February 28, 2020

**Re: Second Adequacy Review of Amendment Application Package AM03, Arcosa  
Lightweight - Boulder, Permit M1988-108 Response to Comments**

## **EXHIBIT F-2**

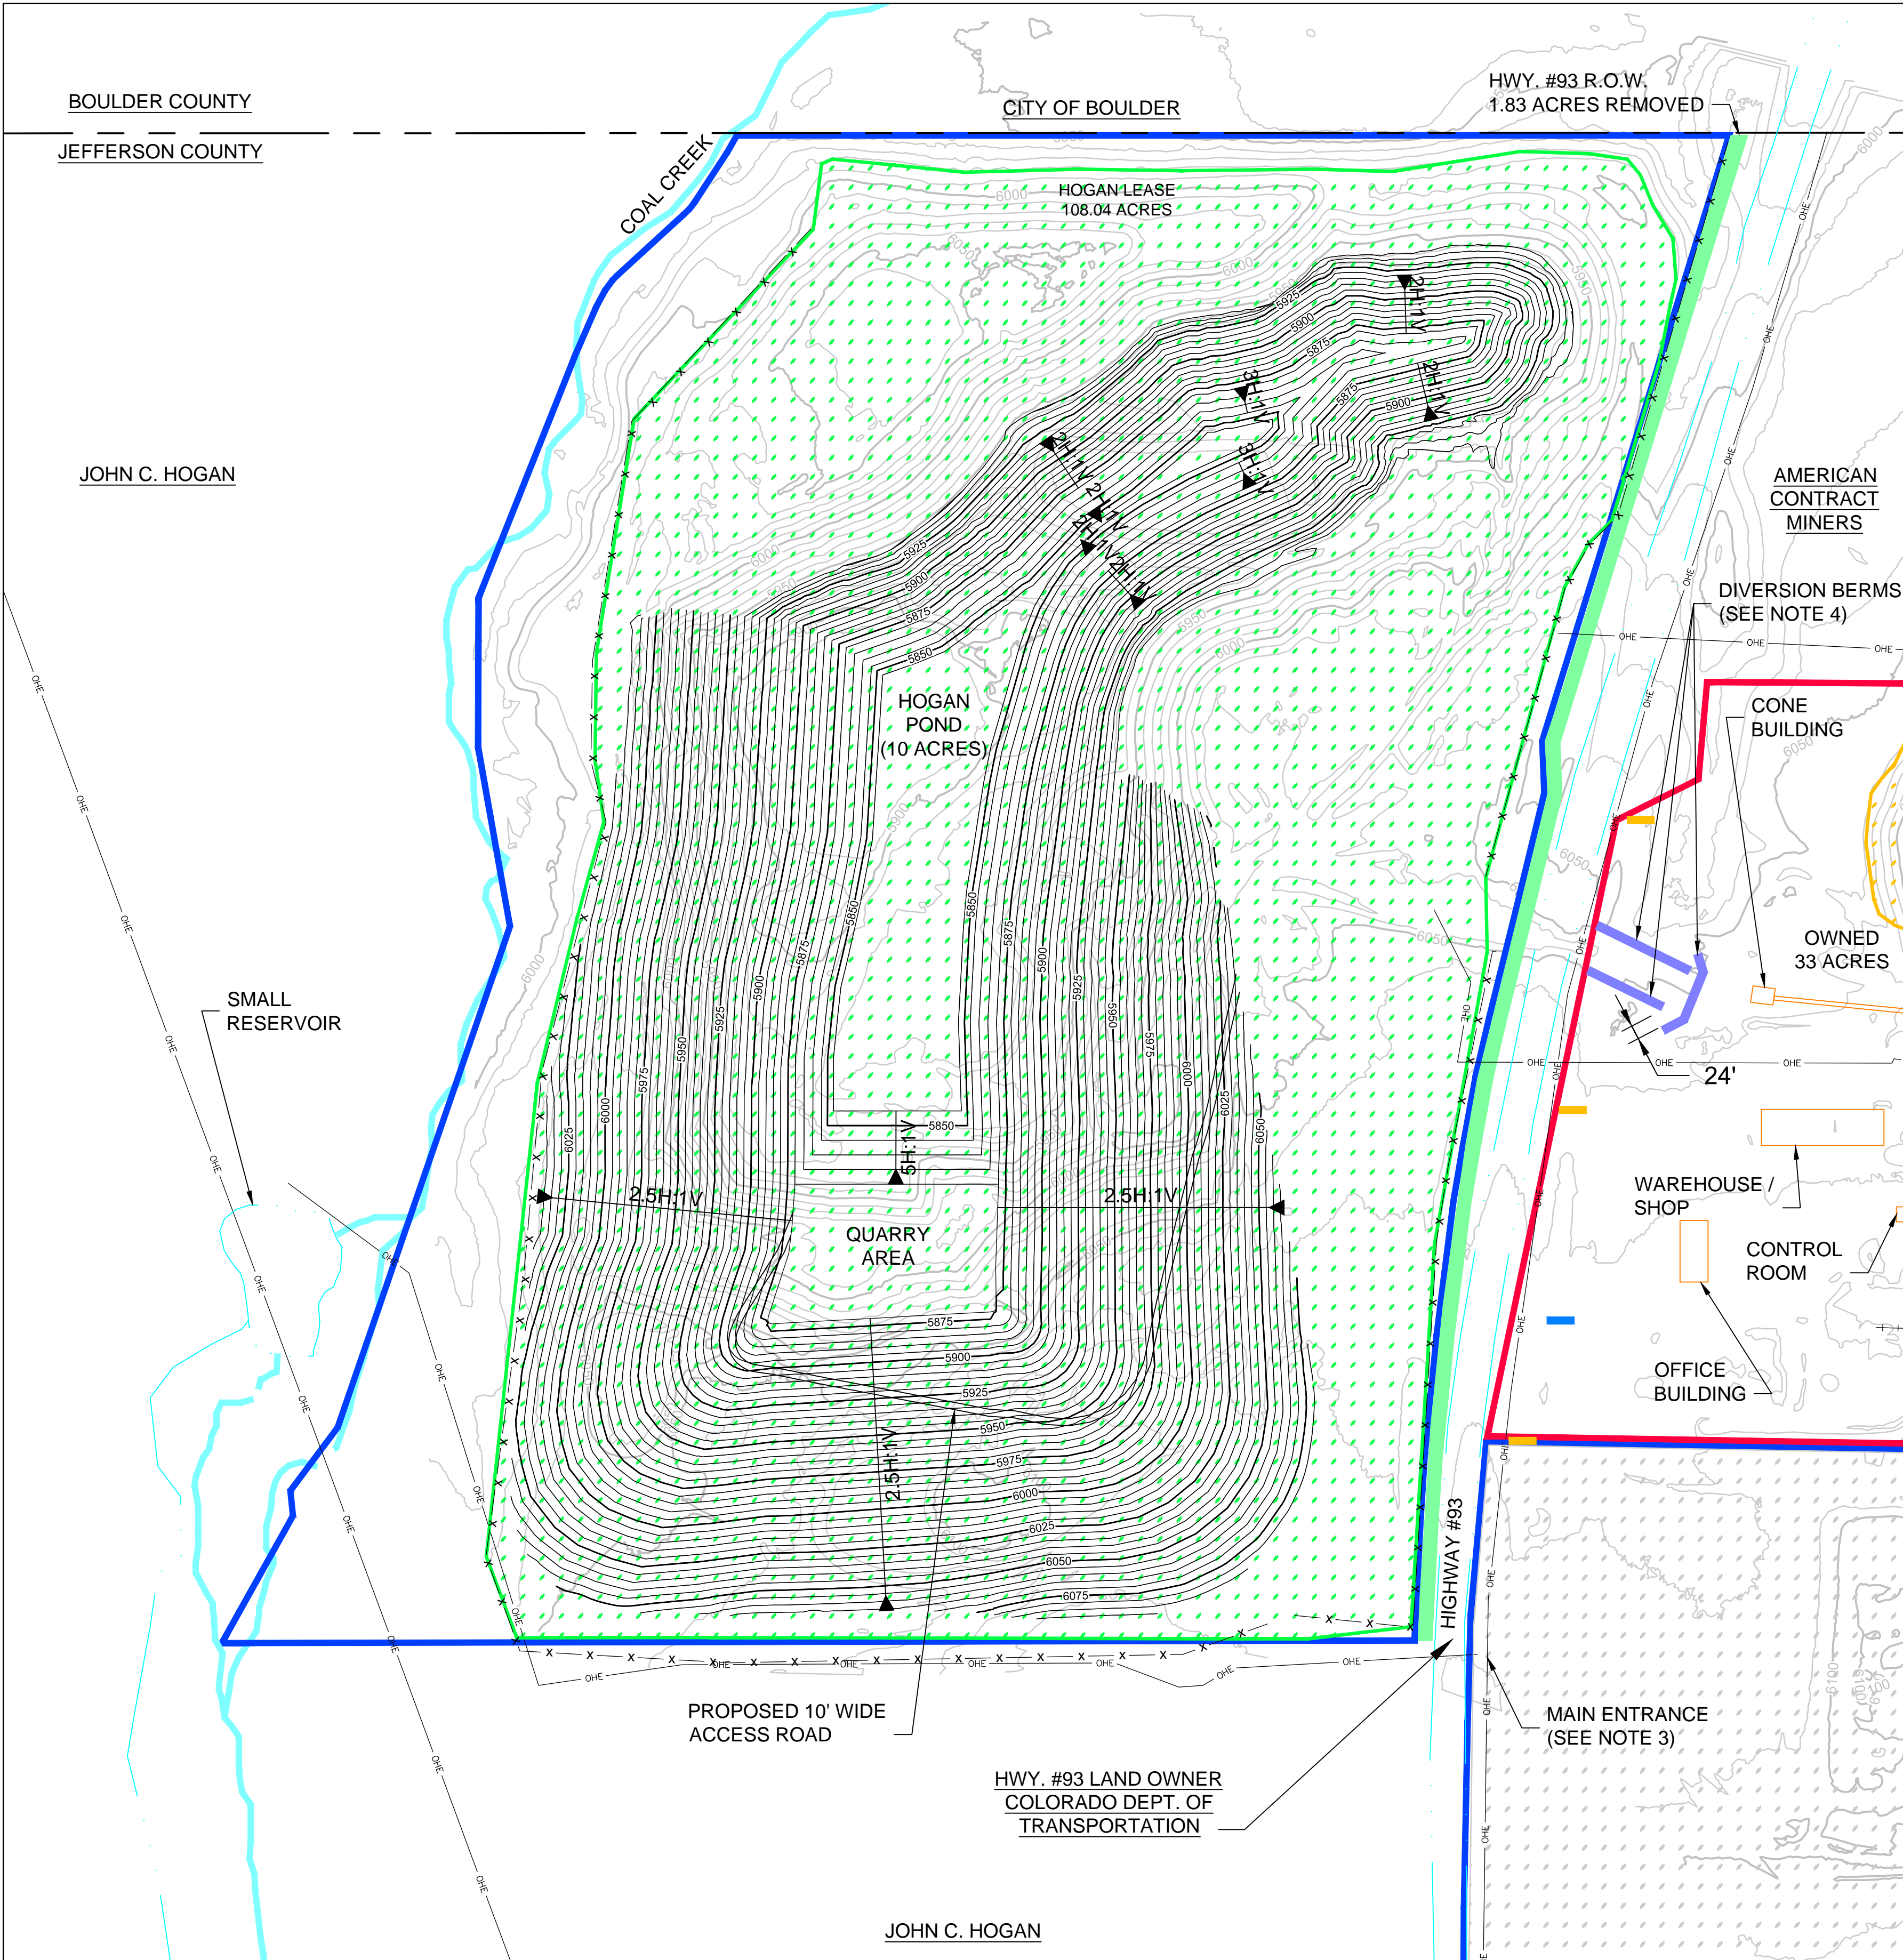
*Please specify what buildings will remain in the process area after reclamation and what buildings will be removed, and make this clear on the reclamation map. Stating that unnecessary industrial buildings and equipment will be removed does not provide sufficient detail for the calculation of that portion of the reclamation bond.*

*Please show what buildings will remain at final reclamation within the processing area.*

See attached updated reclamation plan and updated reclamation maps in Attachment 2.

See attached updated reclamation plan and updated reclamation maps in Attachment 2. At this point, Arcosa assumes all existing buildings within the processing area will remain in place. This final configuration is consistent with the zoning plan for Jefferson County, as described in the Jefferson County Official Development Plan.

5. The volume calculation for soil needed to construct the berms within the processing area is provided in Attachment 3 (Exhibit L).
6. No dam is proposed. See the updated reclamation plan maps (Exhibits F-1 and F-2) in Attachment 2.
